SC Housing Accessibility Consultant Qualifications and Requirements

Accessibility Site Visit (Master)

Accessibility Site Visit Report - HC - ANSI

ACCESSIBLE ROUTE

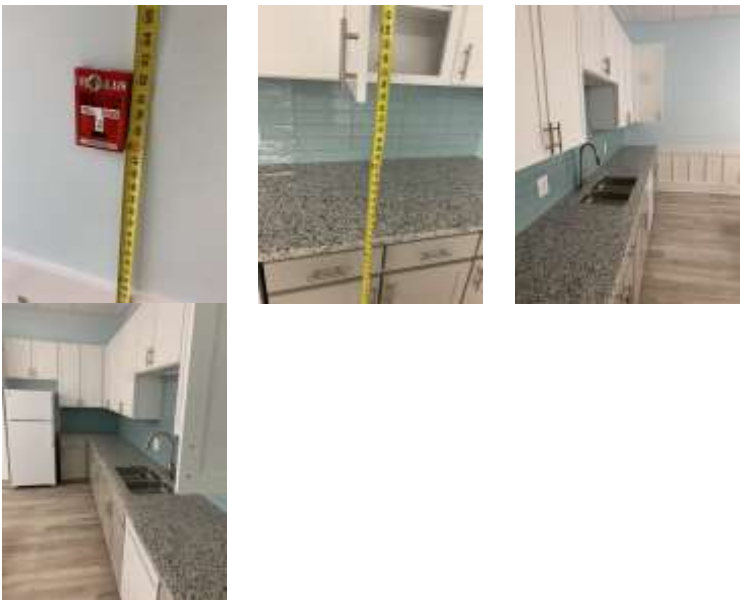
Accessible Route Location	Basement Entrance from HC Parking
Status of accessible route	Finished
Where the accessible route on the site crosses a vehicular roadway, crosswalk lines are provided.	N/A
Accessible route a minimum of 36" (ADA 403.5.1 UFAS 4.3.3)	Yes
Cross-slope is no more than 2% (ADA 403.3 UFAS 4.3.7)	Yes
Forward slope doesn't exceed 5% for a horizontal run over 6 feet and will not require handrails. (ADA 403.3)	Yes
No protruding objects (fire extinguishers, signs, light fixtures, shelves, etc.) project more than 4" between 27" and 80" (ADA 307.3 UFAS 4.4.1)	Yes
18" min clearance with firm surface provided on pull side of the gate (ADA 404.2.4.1)	Yes
Add Photos of Accessible Route

Community Kitchen

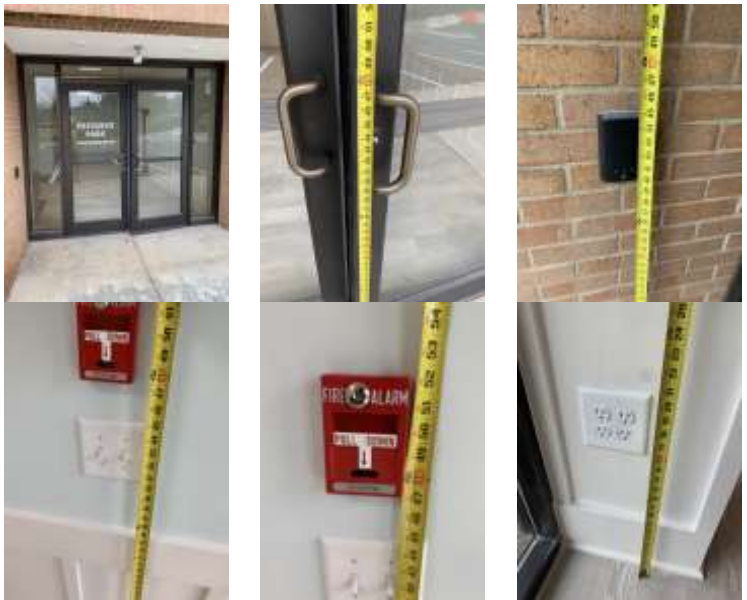
Status of this area	Finished stage
Doorway has a clear opening width 32" min. (ADA 404.2.3)	Yes
Threshold less than 1/2" with bevel or 1/4" no bevel (ADA 404.2.5)	Yes
Interior signs mounted (latch side) have tactile characters (measured from the baseline) between 48" min. - 60" max. (ADA 703.4.1)	Yes
Interior sign characters at least 5/8" but no more than 2" tall (ADA 703.5.5)	Yes
Electric switches/outlets 44" max. AFF over workspace others behind counter 46" max. AFF (ADA 308.2.2 (b))	Yes
Kitchen counters 34" max. AFF (ADA 804.3.2)	Yes
Top lip of kitchen sink 34" max. AFF (ADA 606.3)	Yes
Kitchen sink has 27" knee clearance, 30" clear width, and 9" min. height toe clearance (ADA 306)	Yes
Are drain and water supply pipes insulated or covered by skirt (ADA 606.5)	Yes
Faucet controls Lever Handle style or easy to operate (ADA 309.4)	Yes
Pass through kitchen has 40" min. clear width (ADA 804.2.1)	Yes
At least 50% of shelf space within 48" max - 15" min AFF (ADA 804.5)	No

Cabinet hardware easily operated with one hand (ADA 309)	Yes
Refrigerator has 50% of freezer space below 54" max. AFF (ADA 8.4.6.6)	Yes
If required per NFPA fire alarm pull station permanently installed 48" max. AFF	
Common Kitchen Photos

Fitness Center

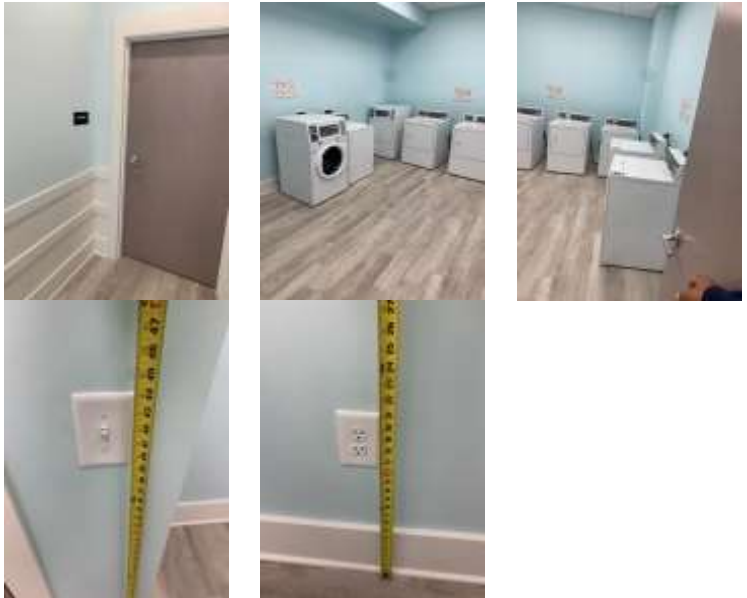
Location of Fitness Center	Basement
Status of this area	Finished stage
Interior signs mounted (latch side) have tactile characters (measured from the baseline) between 48" min. - 60" max. (ADA 703.4.1)	Yes
Interior sign characters at least 5/8" but no more than 2" tall (ADA 703.2.5)	Yes
Doorway has a clear opening width 32" min. (ADA 404.2.3)	Yes
Threshold less than 1/2" with bevel or 1/4" no bevel (ADA 404.2.5 UFAS 4.13.8)	Yes
12" min. clearance on push side of the door (with door closure) (ADA 404.2.1)	Yes
Does the door take at least 5 seconds to close (2010 ADA 404.28.1)	Yes
Electric switches 48" max. AFF and outlets 15" min. (unobstructed) (ADA 308.2.1)	Yes
Clear floor space of 30" X 48" provided at each type of equipment (this space permitted to overlap) (ADA 1004.1)	Yes
Fitness Center Photos

Mail Area

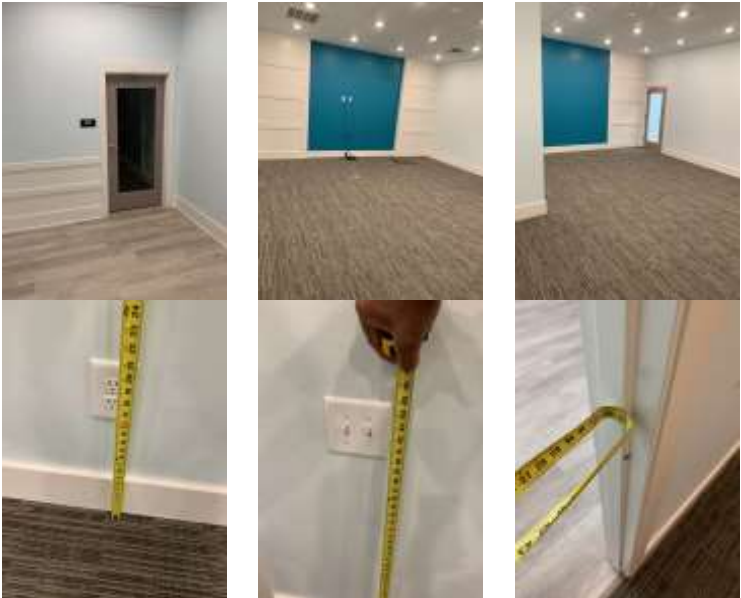
Mail Area Location	Basement
Status of this area	Finished

Is the minimum clear width of the accessible route to the mailboxes at least 36" wide	Yes
Doorway has a clear opening width 32" min. (ADA 404.2.3)	Yes
Is the clear floor space centered on mailbox 30" x 48" unobstructed (ADA 309.2 305)	Yes
Is at least one outbound mail slot 48" max. AFF	Yes
Does the mail area provide 60" x 60" accessible turning (ADA 304.3.1)	Yes
Mail Area Photos

HC Unit Kitchen Photos

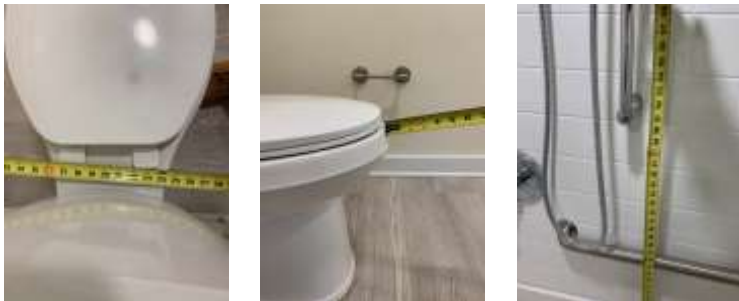
Status of this area	Finished stage
Entrance to kitchen 32" min. (ANSI 404.2.2)	Yes
Electric switches/outlets 46" max. AFF over 24" counter-top obstruction (ANSI 308.3.2)	Yes
Kitchen counter at workspace 34" max. AFF (ANSI 804.3 & 308.3.2)	Yes
Removable cabinet provided at sink with necessary knee clearance for forward approach provided (ANSI 305 & 306))	Yes
Top lip of kitchen sink, 34" max. AFF (ANSI 606.3))	Yes
Are drain and water supply pipes insulated or covered by skirt (ANSI 606.6)	Yes
